Access Compliance Report

Public Rights-of-Way

(Curb Ramps)

Intersection ID: 14505	Main Street: REMOUNT_RD	Cross Street: REMUS_RD	Location:	N
ADA ID: 23399144F4B9	Ramp Type: PerpDiag	Initial Pass/Fail: Fail	Overall Compliance: No	Severity Score: 8.75

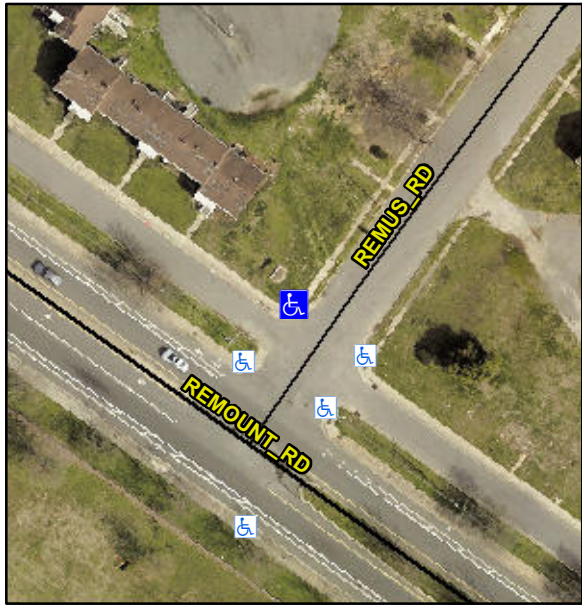
Codes/Mitigation Info/Possible Solution			Field Measurements/Component Compliance					
	Possible Solutions:		Compliance	Description	Data	Compliance	Description	Data
	Remove & Replace Curb Ramp With Two New Directional Ramps or Equivalent.		N/A	Ramp Length (in)	50.0	Yes	Ramp Slope (%)	5.1
			No	Ramp Width (in)	42.0	Yes	Ramp XSlope (%)	0.8
			N/A	Flare Type LT	N/A	N/A	Flare Type RT	N/A
			N/A	Flare Slope LT (%)	N/A	N/A	Flare Slope RT (%)	N/A
			N/A	Flare Traversable LT?	N/A	N/A	Flare Traversable RT?	N/A
			N/A	Landing Length (in)	N/A	N/A	DWS Provided?	N/A
			N/A	Landing Width (in)	N/A	N/A	DWS Contrast?	N/A
			N/A	Landing Slope (%)	N/A	N/A	DWS Length (in)	N/A
			N/A	Landing X Slope (%)	N/A	N/A	DWS Full Width?	N/A
Surveyor Notes:		N/A	N/A	Landing Curb? (Y/N)	N/A	N/A	DWS Offset (in)	N/A
			N/A	Shared Landing?	N/A			
PROW/ADA:			N/A	Gutter Ponding?	N/A	N/A	Gutter Slope (%)	N/A
Not Found, R304.5.1			N/A	Gutter Lip Ht (in)	N/A	N/A	Gutter X Slope (%)	N/A

N/A	Painted X Walk1?	No	N/A	Painted X Walk2?	No
				X Walk 1 Direction	To SW		X Walk 2 Direction	To SE
			N/A	X Walk 1 Width (in)	N/A	N/A	X Walk 2 Width (in)	N/A
				X Walk 1 Slope (%)	3.2		X Walk 2 Slope (%)	1.9
				X Walk 1 X Slope (%)	0.1		X Walk 2 X Slope (%)	2.0
			N/A	Ramp inside XWalk1?	N/A	N/A	Ramp inside XWalk2?	N/A
				Road Slope (%)	1.1	N/A	Clear Space?	N/A
				Road X Slope (%)	4.6	N/A	Clear Space to XWalk (in)	N/A
			N/A	Any Obstructions?	N/A	N/A	Storm Grate/Utility Hazard?	N/A
				Obstruction Type			Storm Grate/Utility Type	
					N/A			N/A
						Yes	Surface Condition? (G/P)	Good
							</
